UNITED STATES PATENT AND TRADEMARK OFFICE

APPLICATION NO.	FILING DATE	FIRST NAMED INVENTOR	ATTORNEY DOCKET NO.	CONFIRMATION NO.
10/629,831	07/30/2003	Akira Tsumiyama	SN-US035024	7279

Office Action Summary

ATTACHMENT # 1

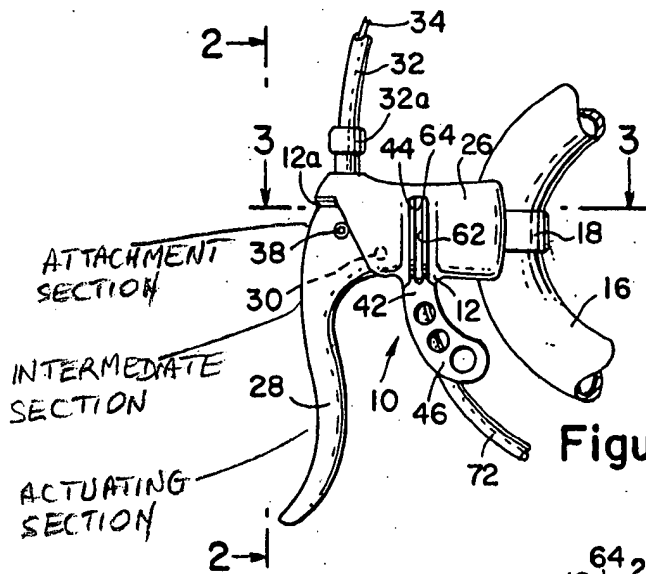
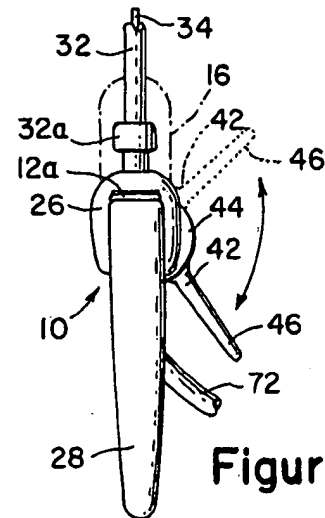
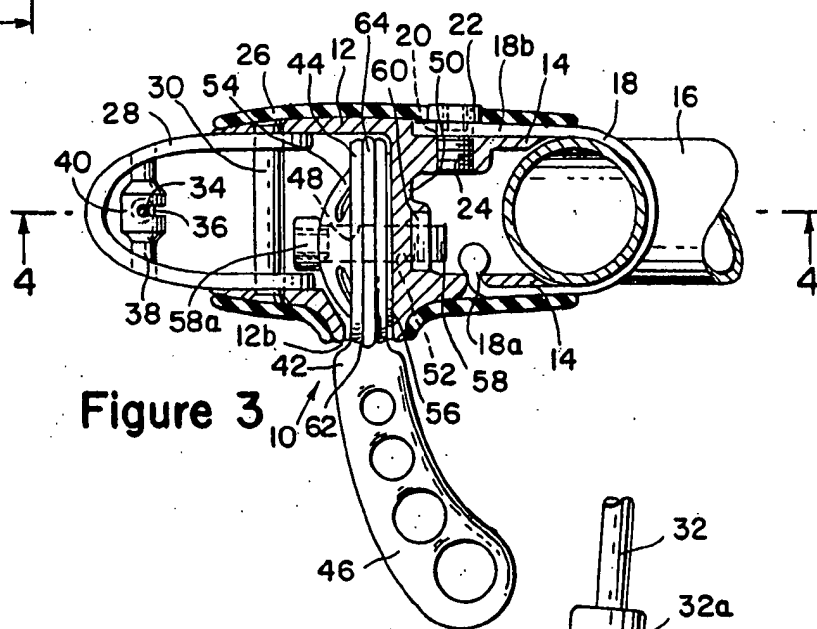
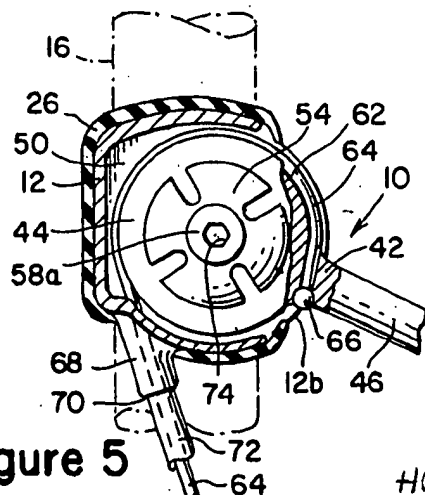
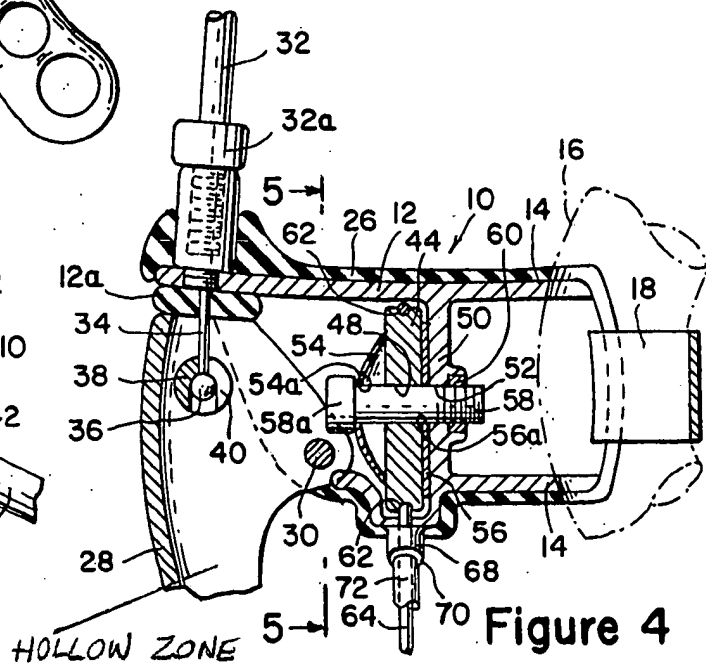
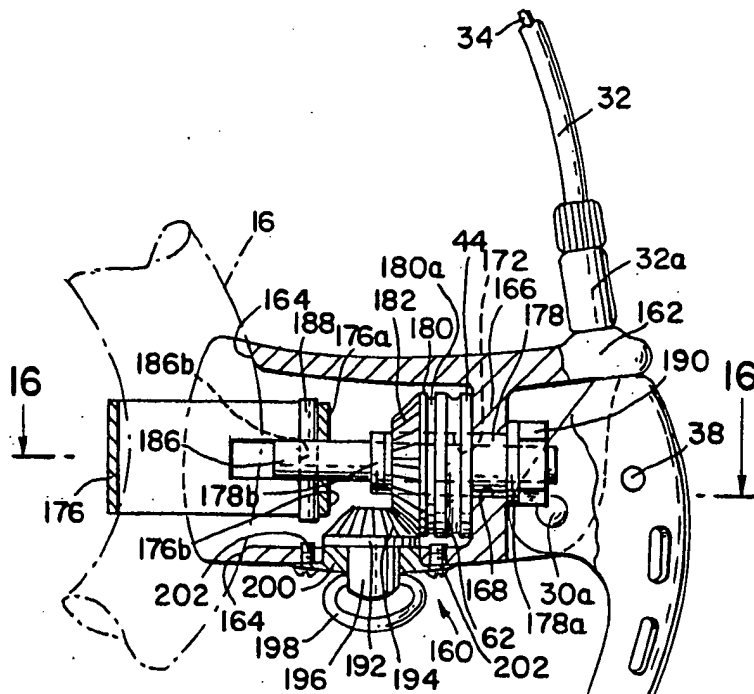
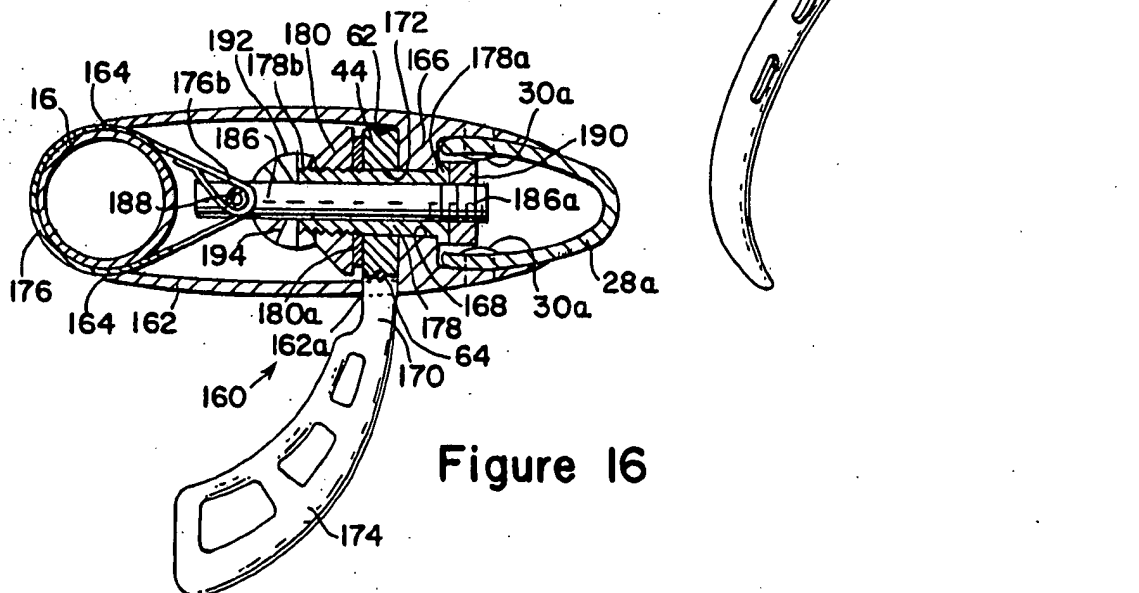
a control lever 28 operatively coupled to the control mechanism 44, etc., the control lever 28 including an attachment section (see Attachment 1), an intermediate section (Att. 1) extending from the attachment section (Att. 1) and an actuating section 28b (Fig. 17 and Fig. 1 in Att. 1) extending from the intermediate section (Att. 1), the attachment section (Att. 1) being operatively coupled to the control mechanism 44, etc., at least one of the intermediate section (Att. 1) and the actuating section (Att. 1) having a hollow zone (e.g., Fig. 4, Att. 1) formed therein that extends axially along the at least one of the intermediate section (Att. 1) and the actuating section (Att. 1) of the control lever 28.

Regarding claim 2, the control lever 28 is operatively coupled to the control mechanism 44, etc. to inherently move along a first plane between a rest position and a operating position and along a second plane substantially perpendicular to the first plane between the rest position and a first position vertically spaced from the rest position in a manner similar to Applicant's Figs. 8 and 9 (see Fig. 17 in Att. 1).

ATTACHMENT # 2

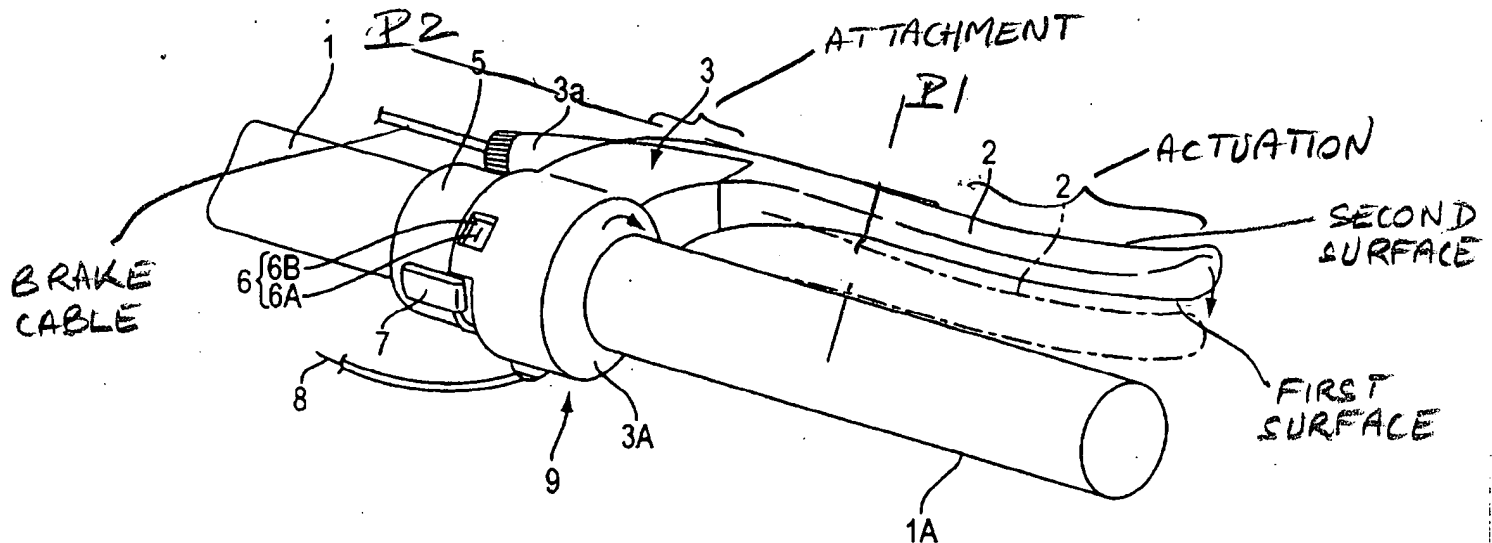
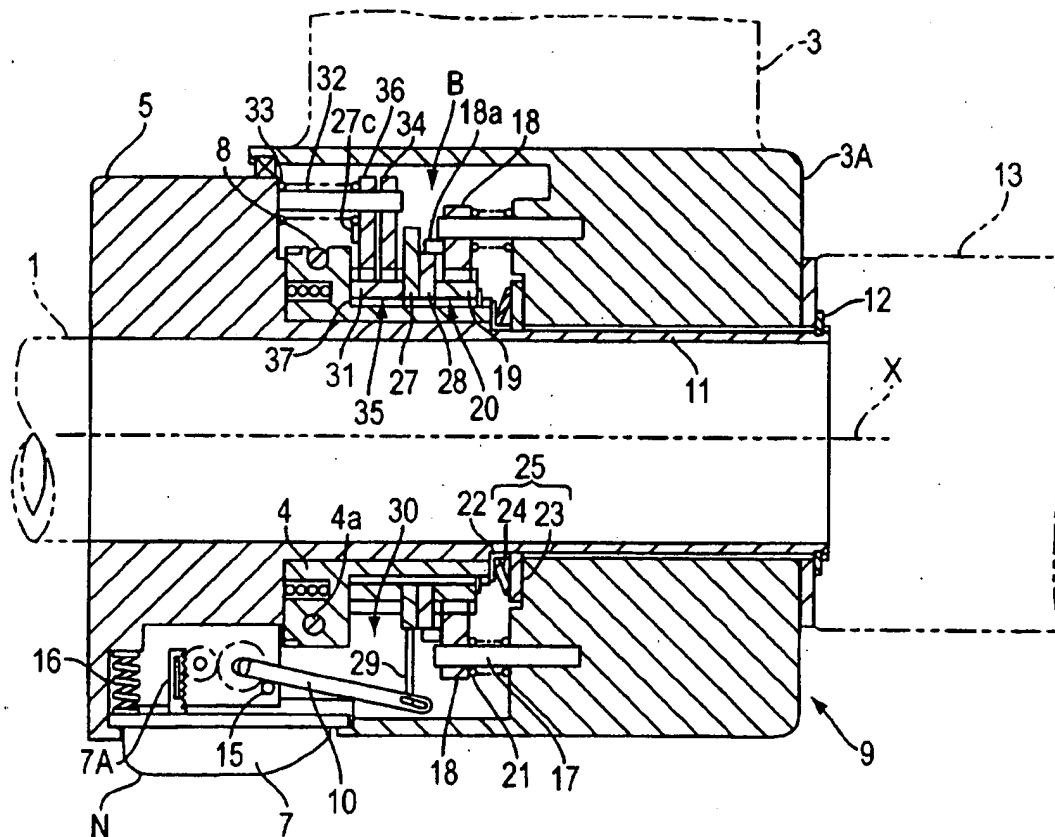
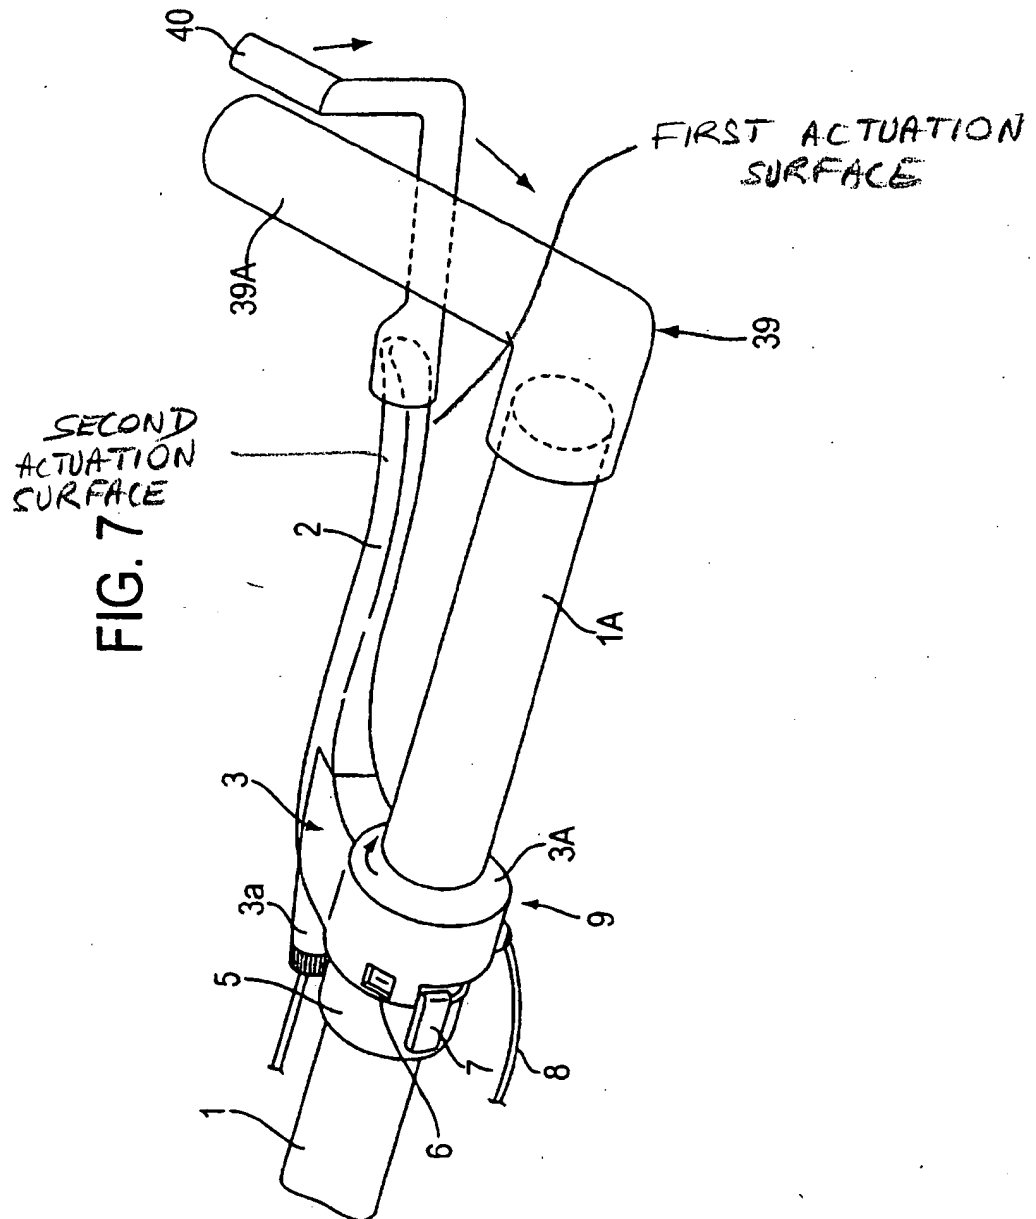
a control lever 2 or 2, 40 operatively coupled to the control mechanism 9 to move along a first plane (P1. See Attachment 2) between a rest position and a operating position and along a second plane (P2, Att. 2) substantially perpendicular to the first plane (Att. 2) between the rest position and a first position vertically spaced from the rest position, the control lever 2 or 2, 40 including an attachment section (Att. 2) and an actuating section (Att. 2) extending from the attachment section (Att. 2); the attachment section (Att. 2) being operatively coupled to the control mechanism 9, the actuating section (Att. 2) having a first actuation surface extending in a direction substantially perpendicular to the first plane and an inclined second actuation surface (Att. 2) facing substantially away from the first actuation surface (Att. 2) downwardly and towards the handlebar 1, 1A, the inclined second actuation surface (Att. 2) extending in a direction intersecting the first and second planes, the inclined second actuation surface (Att. 2) having a transverse height that is at least one-half of the transverse height of the first actuation

Regarding claim 12, the control lever 2 or 2, 40 includes a brake cable attachment portion arranged and configured to pull a brake control cable (Fig. 1, Att. 2) upon movement of the control lever 2 or 2, 40 from the rest position to the operating position when a substantially rearward force is applied to the first actuation surface (Att. 2).

a control lever 2 or 2, 40 operatively coupled to the control mechanism 9, the control lever 2 or 2, 40 including an attachment section (Att. 2), an intermediate section (Att. 2) extending from the attachment section (Att. 2) and an actuating section (Att. 2) extending from the intermediate section (Att. 2), the attachment section (Att. 2) being operatively coupled to the control mechanism 9.

Furuta teaches the invention substantially as claimed. However, Furuta does not teach at least one of the intermediate section (Att. 2) and the actuating section (Att. 2) having a hollow zone (e.g., Fig. 4, Att. 2) formed therein that extends axially along the at least one of the intermediate section (Att. 2) and the actuating section (Att. 2) of the control lever 2 or 2, 40.
